PLANNING APPLICATIONS COMMITTEE

ADDENDUM 9th May 2023

**SUPPLEMENTARY TRANSPORT NOTE
PROPOSED CONVENIENCE STORE
THE CROWS NEST PH, RAVEN WAY
ATTLEBOROUGH, NUNEATON, WARWICKSHIRE, CV11 6PJ
ADL REF: 5431/AM/03A, 3rd MAY 2023**

Figure 2A Raven Way Widths

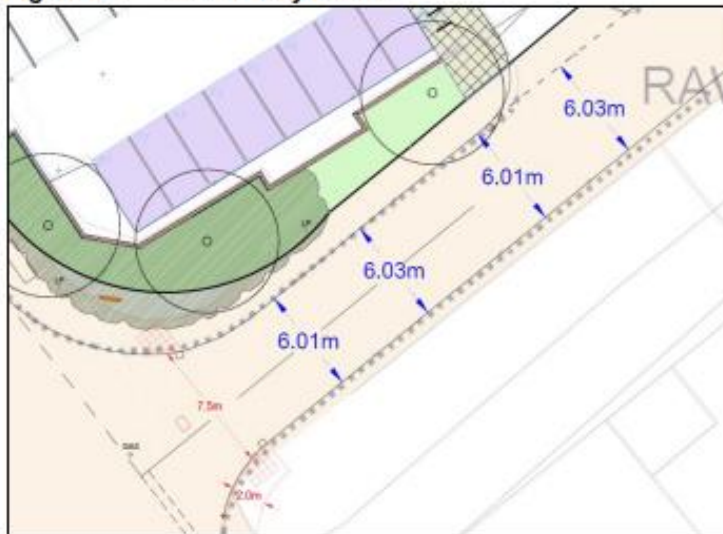
2.1 The road widths on Raven Way between its junction with Crowhill Road and the site access are 6.0m. The Raven Way carriageway widths are shown in Figure 2A below.

Figure 4A Crossing Width Comparison

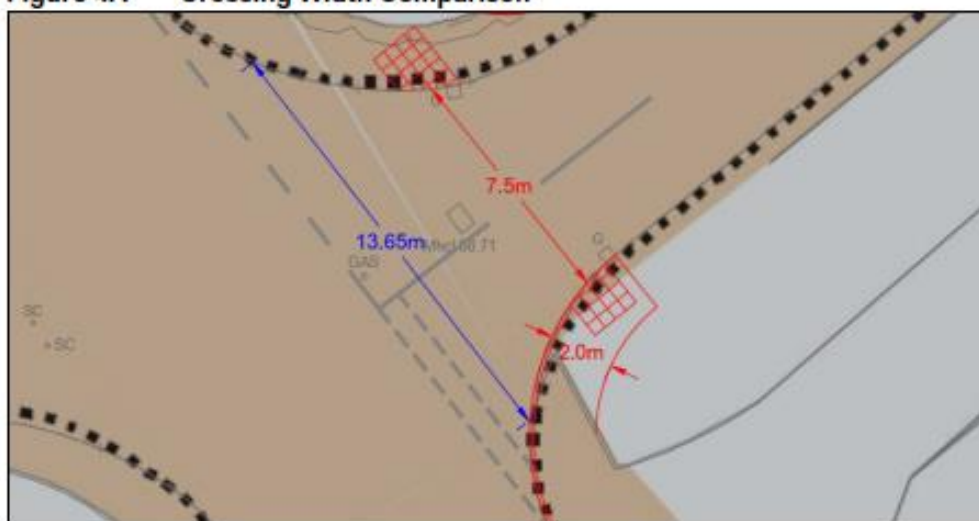
- 4.1 As noted within the Committee Report, the Applicant has agreed with the Highway Authority to provide an improvement to the existing sub-standard crossing point at Crowhill Road / Raven Way.
- 4.2 The initial, and preferred option, as presented within the appended drawing 5431-06 is to provide a continuation of the footway around the southeastern radius of the junction in order to provide new dropped kerbs and tactile paving at the narrowest point result in a crossing width of 7.5m rather than 13.65m as occurs as existing when crossing nearer the give-way line. This was on the recommendation of the Stage 1 Road Safety Audit. See Figure 4A for clarification.

4.3 Also shown within Figure 4A are the adopted Council highway extents, shown with a brown solid hatch. It is apparent that the proposals fall outside of the highway extents, however we understand that this land is owned by the Council and that confirmation has been sought by the Highways Officer from the Council's property team, which is pending.

Figure 5A Additional disabled accessible bay

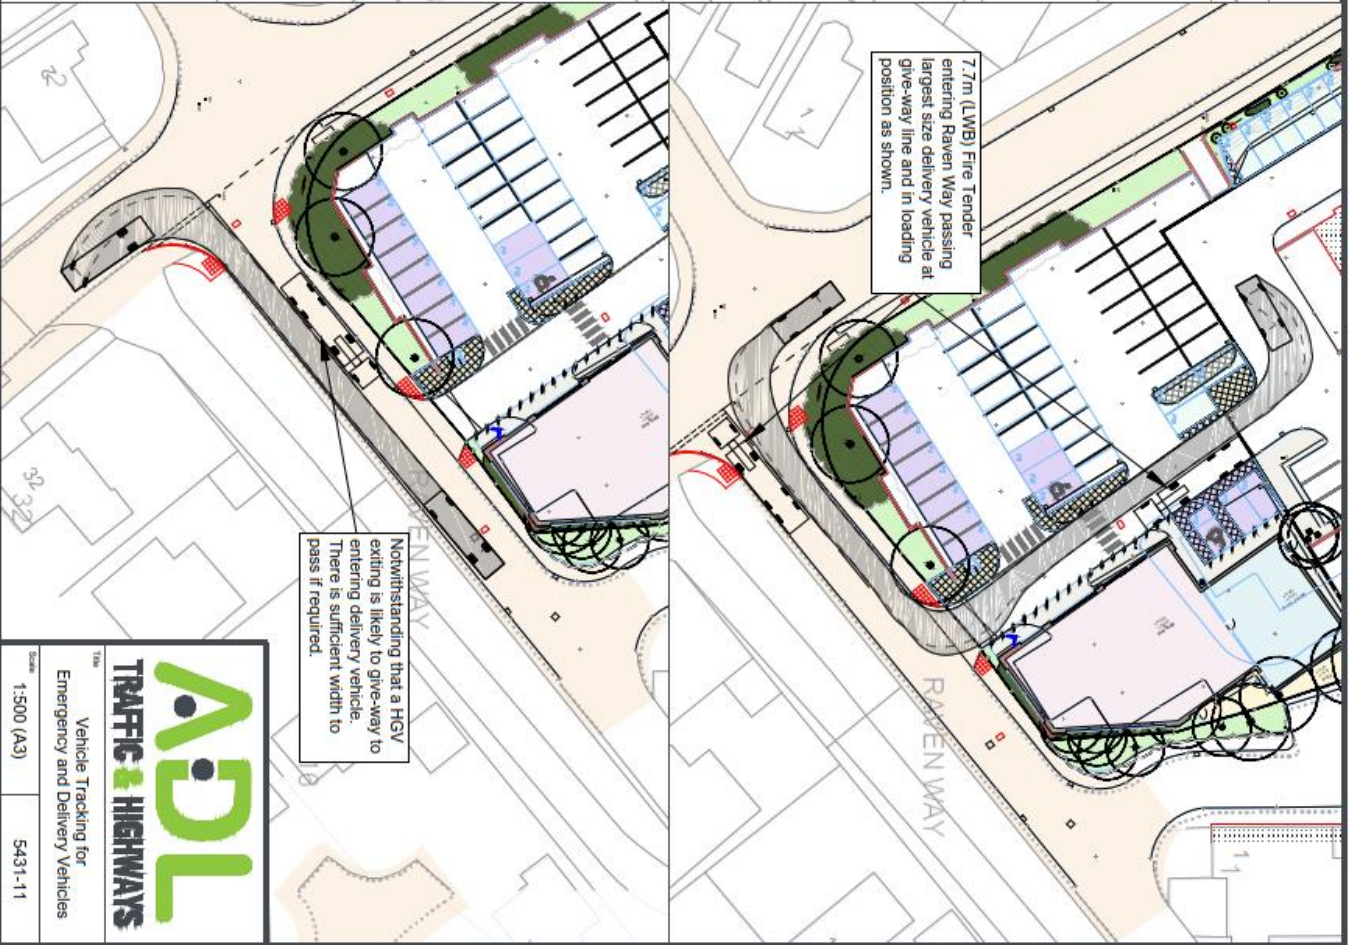
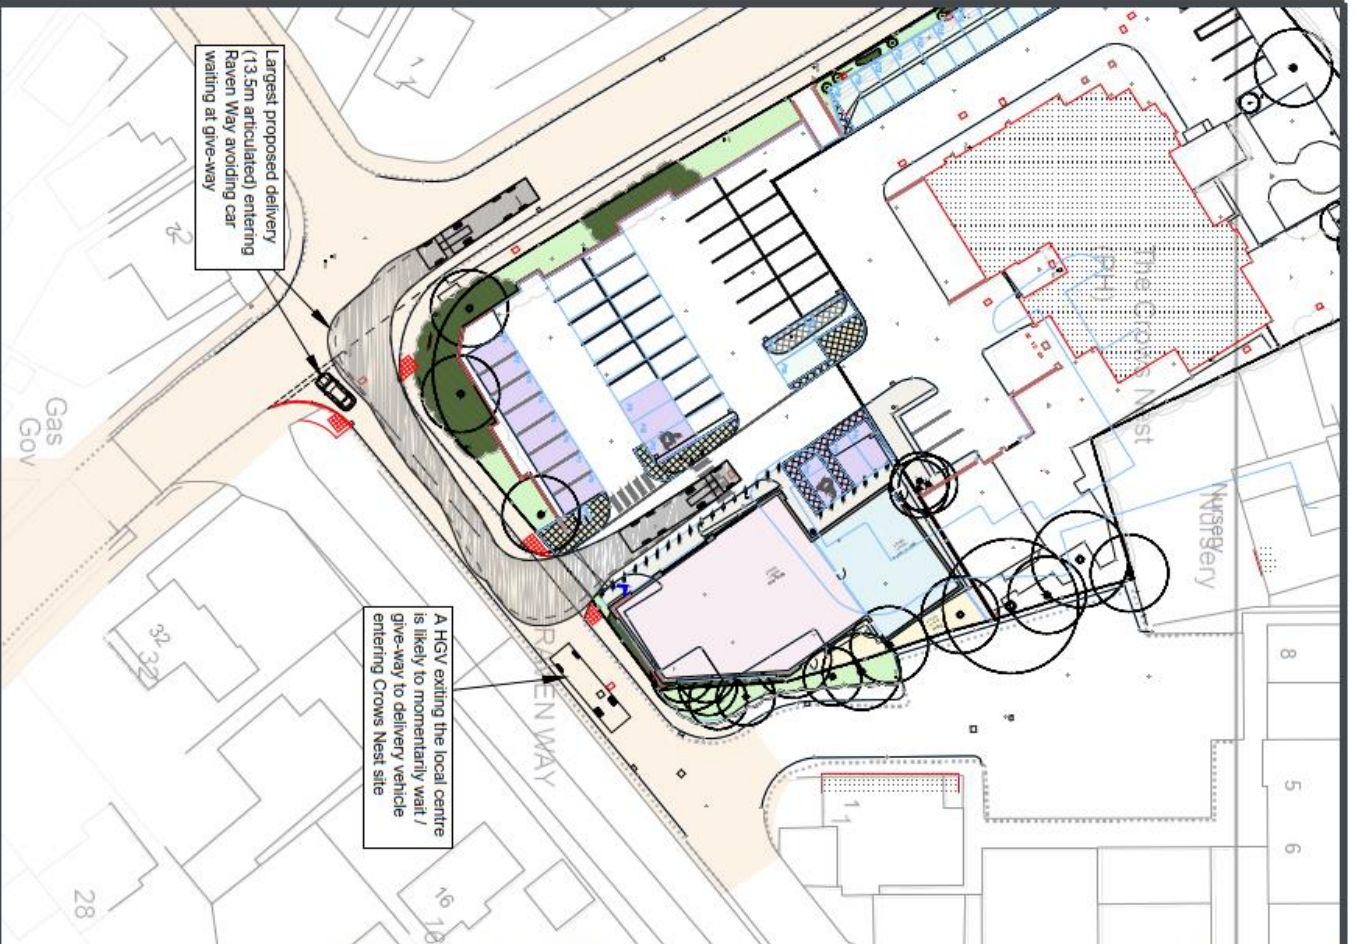
5.2 Whilst it is noted that the parking standard requires only one disabled accessible bay, it is considered prudent to provide one additional disabled accessible bay so that there will be a minimum of one space available for use at all times.

5.3 The site layout has accordingly been updated to provide an additional disabled space as close as possible to the crossing and store entrance, whilst maintaining the car parking numbers – see Figure 5A..

Vehicle Tracking for
 Emergency and Delivery Vehicles

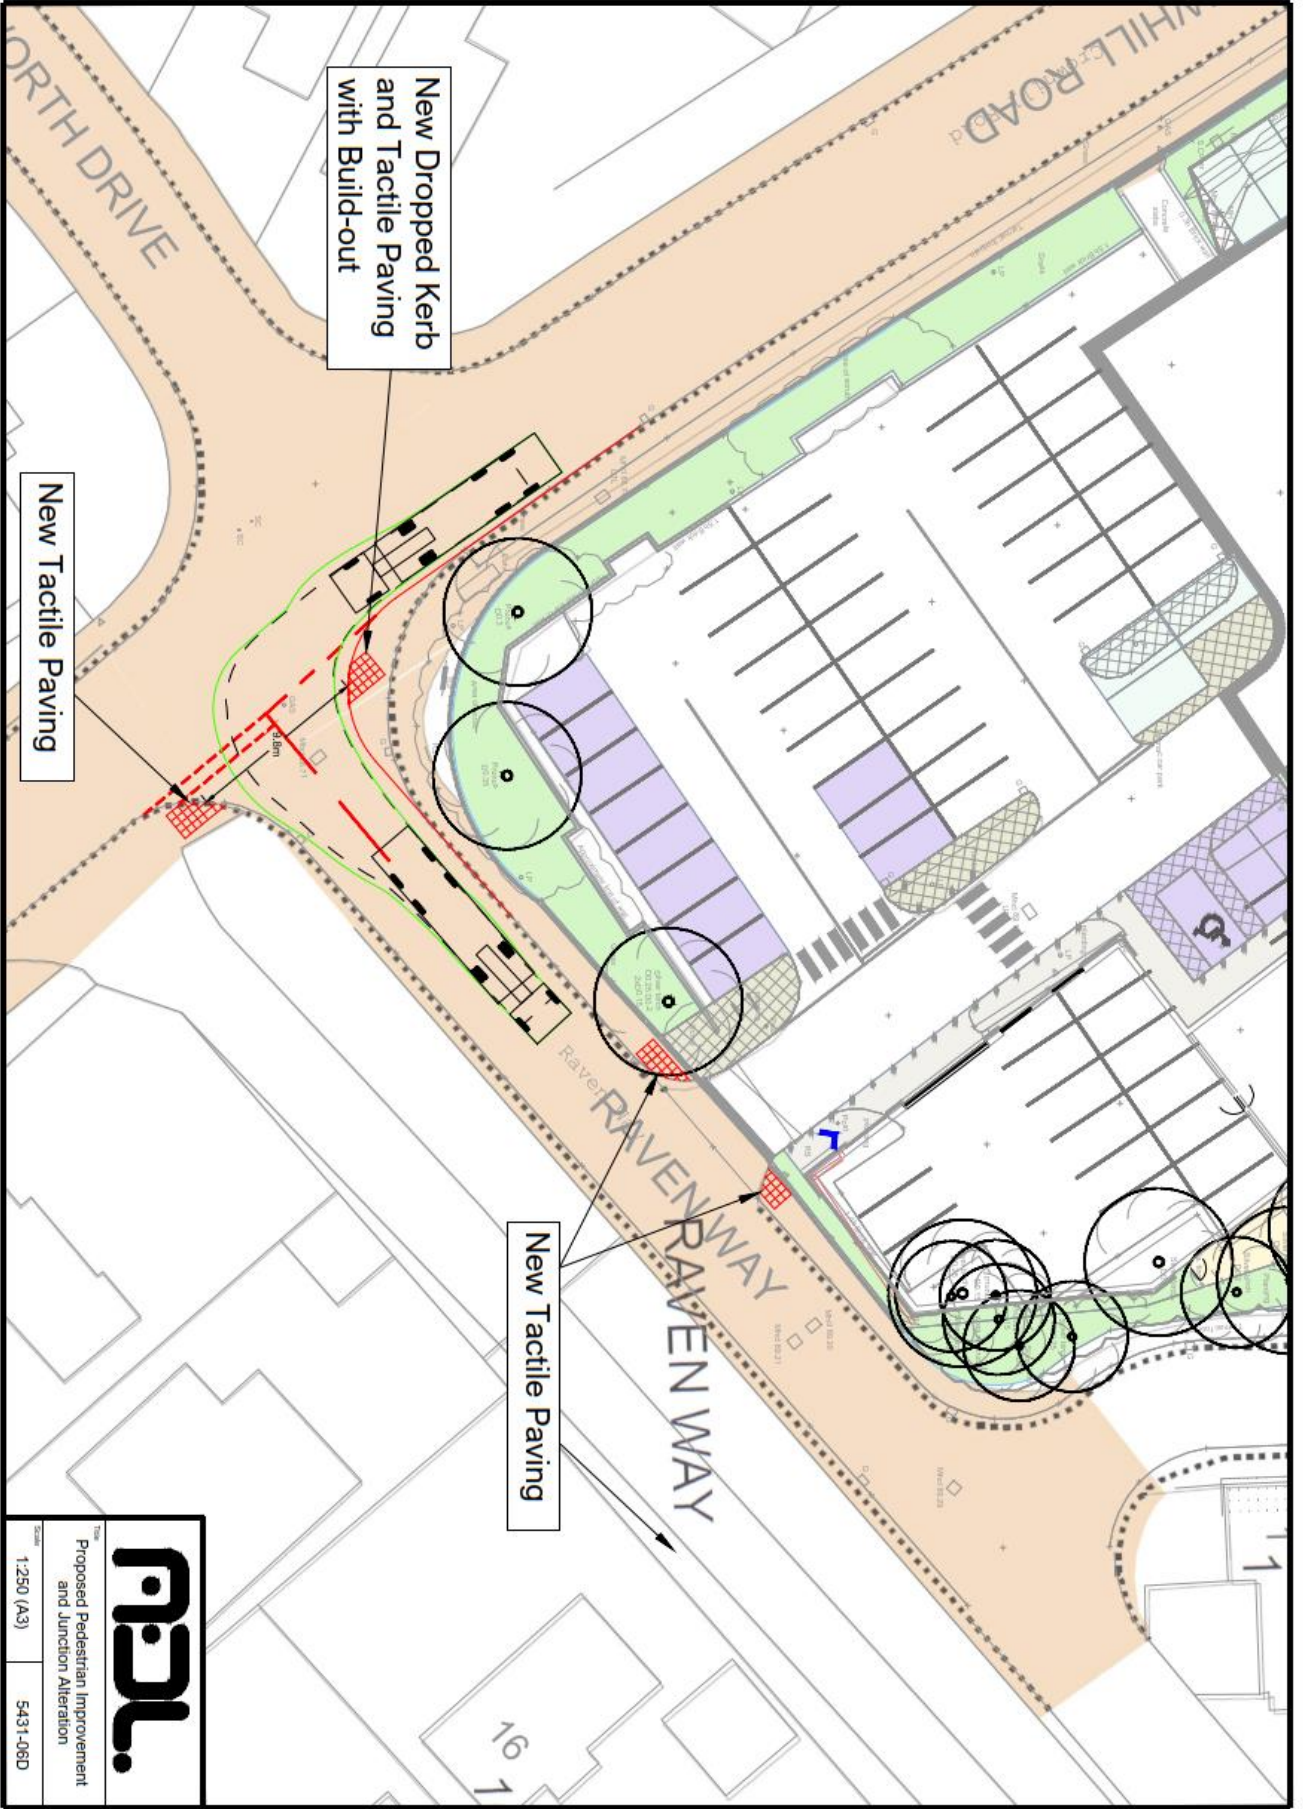
3.2 Therefore notwithstanding the previous determination of road width dimensions, the vehicle tracking for Heavy Goods Vehicles (HGVs) and Emergency service vehicles travelling on Raven Way are provided as Drawing 5431-11 showing a number of scenarios for HGVs and emergency service vehicles entering / exiting Raven Way and the site. As annotated on the drawing 5431-11, in the unlikely event that a HGV is exiting Raven Way (say from the Local Centre) at the same time as the largest size convenience store delivery vehicle is entering Raven Way, it is likely that the exiting vehicle will momentarily stop and give-way to the entering vehicle.

- 3.4 Notwithstanding this, the drawing 5431-11 demonstrates that vehicles would be able to give-way or pass one another at convenient locations, except for when undertaking turning movements where HGVs would typically instead wait / give-way to the entering vehicle. This is supported by Manual for Streets which states:
